RE: Hampton Downtown Victoria – Design Revision Memo

The design team has given further study to the proposed façade design, in response to application review comments and in preparation for the presentation to the Heritage Advisory Panel. The intent of these design adjustments is to strengthen the architectural fit to context through refinements to the façade scale, articulation and expression of structure. The following list outlines the design revisions, keyed by numbers to the 'clouded' resubmission package.

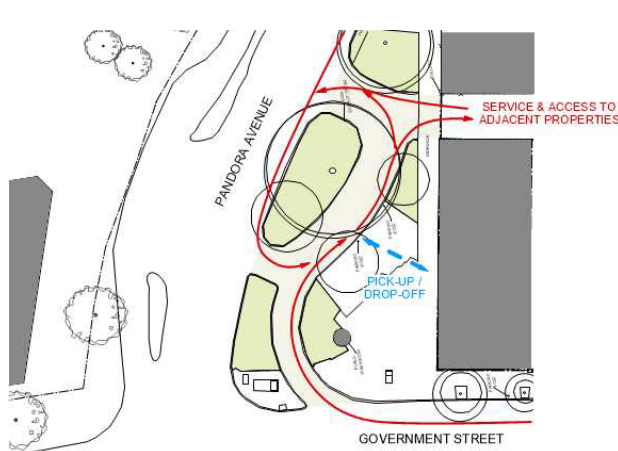
Rev. 4: Vehicle Access Revisions

Drawings: A1.3 Site Plan, A2.5 Level 1 Plan

- New sidewalk East of access lane to provide a safe pedestrian path from the curbside sidewalk to the in-bound sidewalk and Plaza access. Bollards have been added to delineate the edge of the vehicle access lane. The proposal prioritizes pedestrian use of the Pandora public frontage, significantly reducing the area dedicated to vehicle access from the current condition:

Proposed plaza and reduced vehicle access

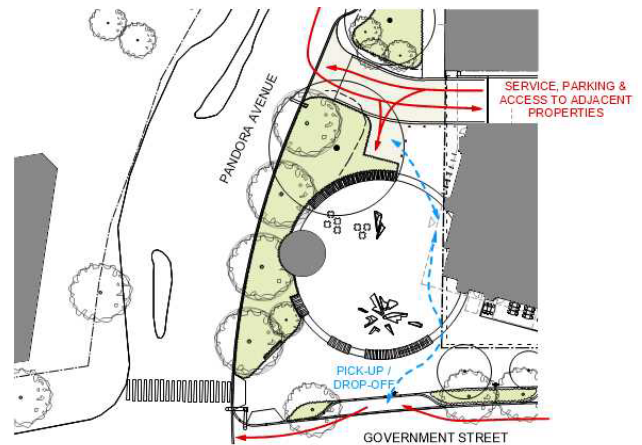
Vehicle access remaining from the former Plaza Hotel
